Airport Link

**Wooloowin Worksite Modification
Application for Project Change**

Response to Submissions

August 2009

Figure 5-2: Proposed Children's Crossing at Kedron State High School

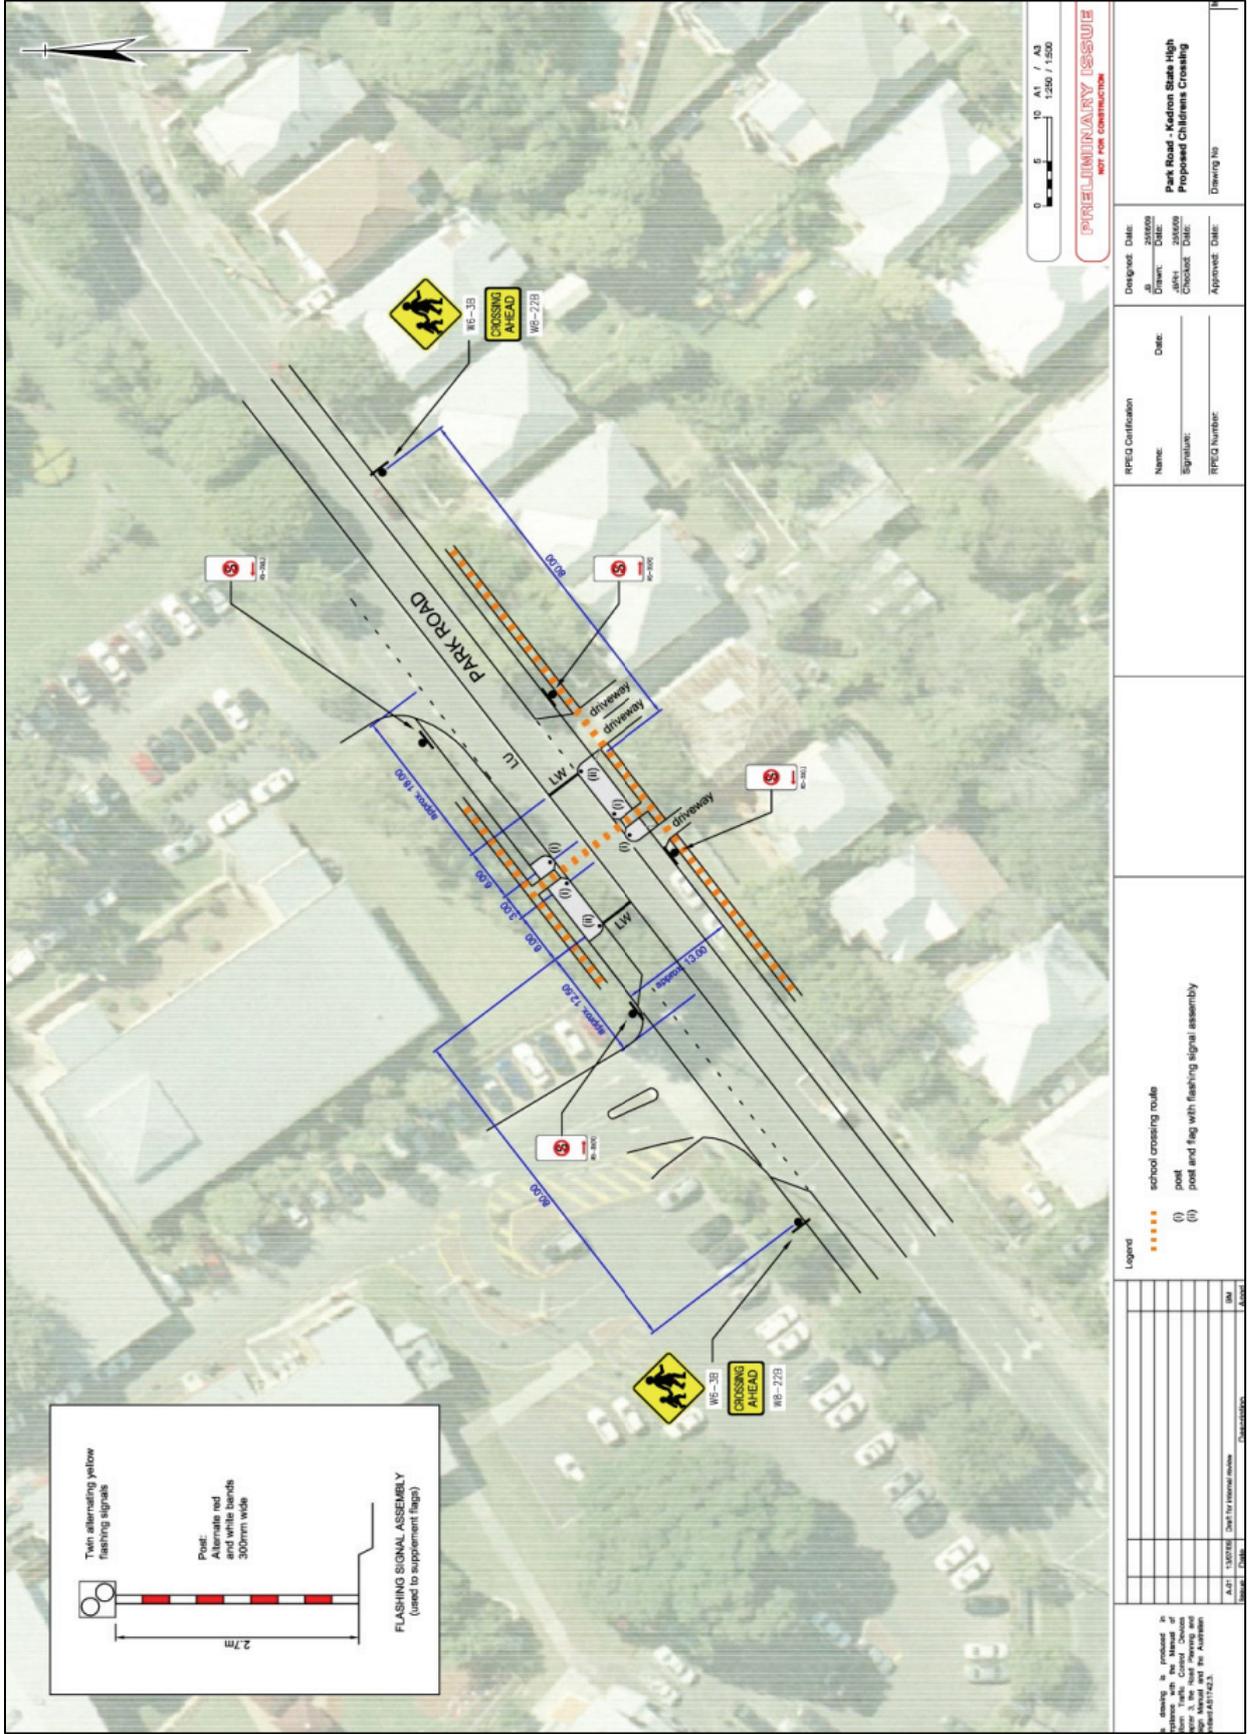
In order to mitigate these behaviours and improve student safety, it is proposed to install a children's crossing on Park Road between the DES driveway and the school driveway (**Figure 5-2**) A pedestrian (zebra) crossing is not warranted at this location as there is not substantial pedestrian use other than school children during and outside school hours. A children's crossing is warranted as:

*A pedestrian crossing must be provided in Park Road adjacent to the Kedron Park State High School, consistent in detail with the conceptual design presented in **Figure 5-2**, Section 5.15 of this response report. The pedestrian crossing must comply with QTMR standards and must incorporate an appropriate range of traffic controls including flashing lights in the 40km/h zone, coloured band marking on the roadway, and electronically variable speed signs in the school zone.*
